Executive Summary from Appellant – Pam Brandon
Re: Appeal of the ABR preliminary approval for 903 W. Mission St.

Perspicitve From Backyard of Adjacent Property
Existing home and 2 car garage

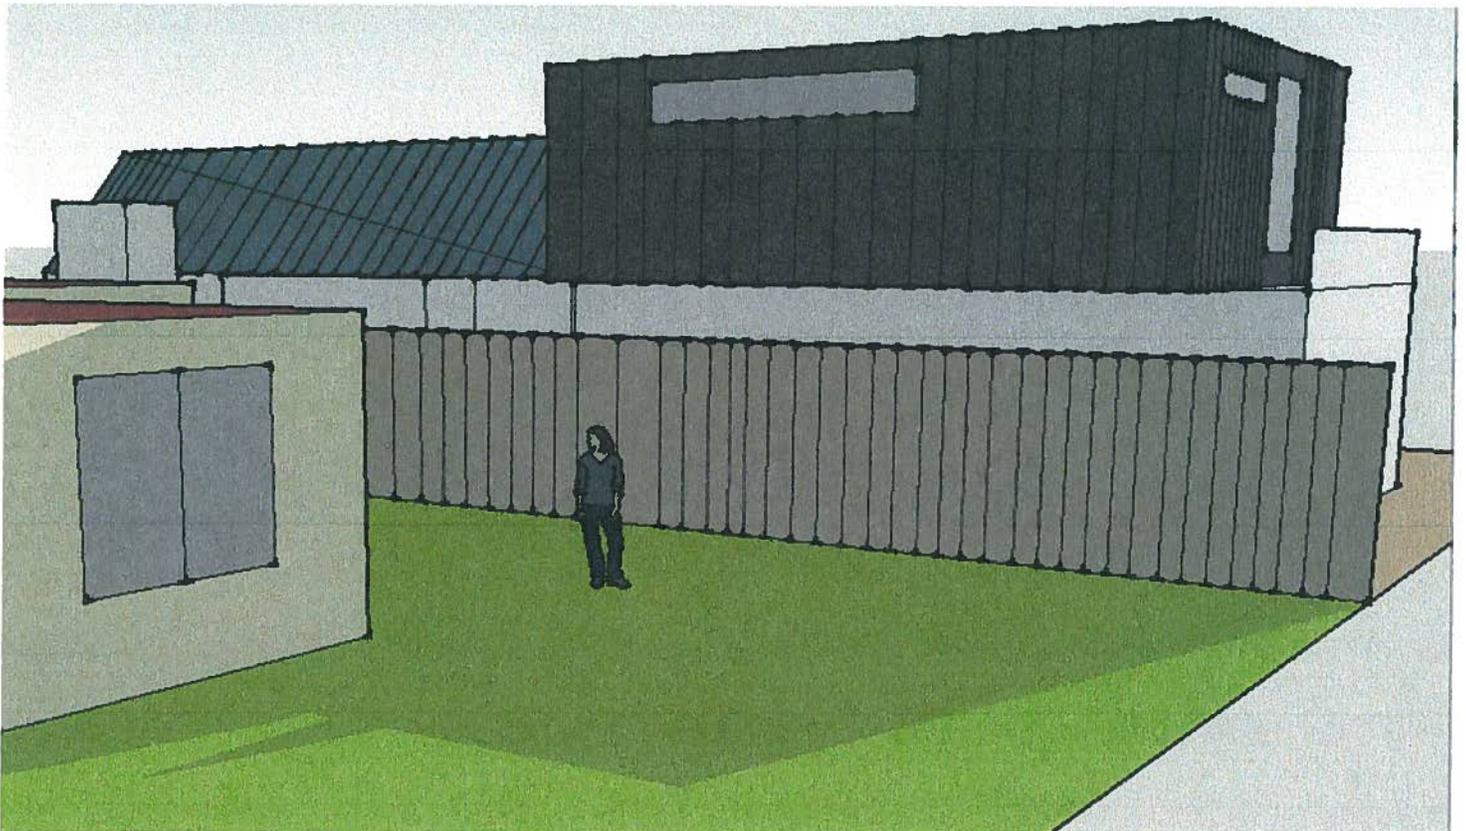
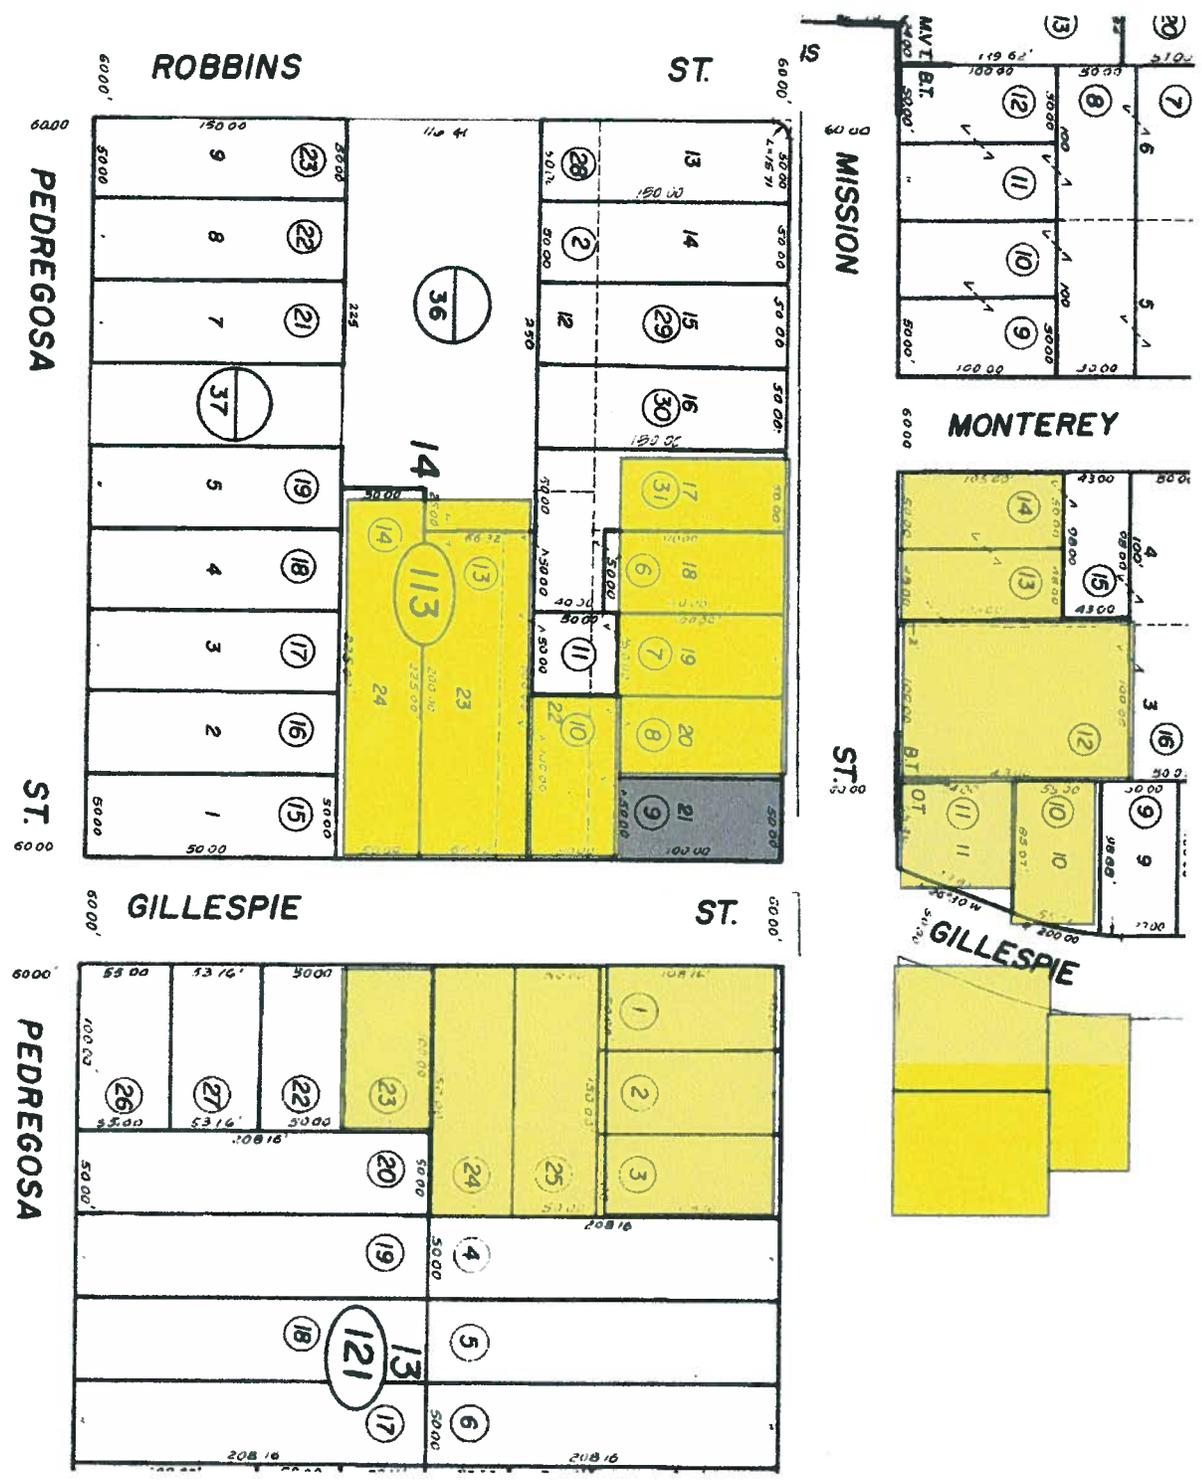
Disclaimer: I can't guarantee the drawings are 100% accurate, but should be very close in size. I made these drawings for the purpose of showing the scale and massiveness of the proposed project. Therefore, I don't have the windows drawn in the first floor, doors, landscaping, etc.
